Please find Hollywood Heritage's comments in response to the Hollywood and Wilcox Project DEIR (ENV-2016-3177-EIR). If you have any questions do not hesitate to ask.

**Re: "Hollywood and Wilcox"**  
**City Case No. ENV-2016-3177 -EIR**  
**Addresses: 6430 -6440 Hollywood Boulevard and 1624-1648 N. Wilcox Ave**

**Environmentally Superior Alternative**

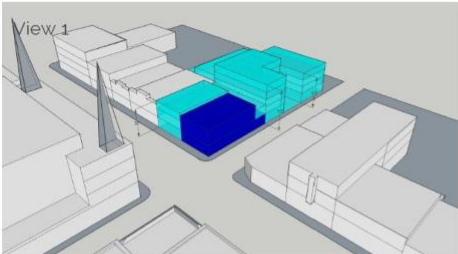
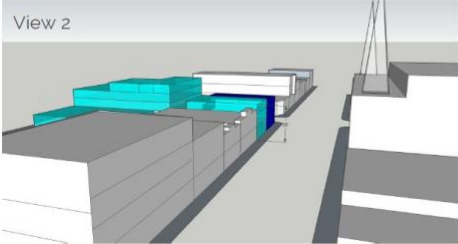
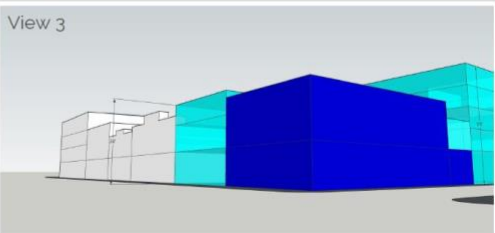
- Developed in accordance with existing C4-2D-SN zoning with FAR limitation of 2:0:1. This would develop 123,952 sqft of uses instead of 278,892.
- Would retain but not restore the Attie
- Uses would be 125 units (no workforce housing) and 14,600 sqft for retail and 3,200 for restaurant (less retail and no office, compared to proposed), 15,000 open space
- 222 parking spaces, .5 ground level and 2 above ground (no 10% reduction in parking compared to proposal)
- New buildings between 1-8 stories, max height 90 ft
- Would not seek certification under AB 900 Jobs and Econ improvement thru environmental leadership

- Under the Proposed Hollywood Community Plan Update the project site would be designated a Regional Commercial Center with a zoning designation of C4-2D-CPIO with FAR limitation of 3:1 and max height of 75 ft
- Would retain but not restore the Attie
- 127,375 sqft of new use - 123 multi-family housing units (no workforce housing), 14,600 sqft for retail and 3,200 for restaurant, 14,375 open space
- New buildings between 1 and 7 stories, max height 75 ft
- 222 parking spaces, 1 subterranean level, .5 ground level and 1 above ground (no 10% reduction in parking compared to proposal)
- Would not seek certification under AB 900 Jobs and Econ improvement thru environmental leadership
- Does not say if they would keep 6434 Hollywood
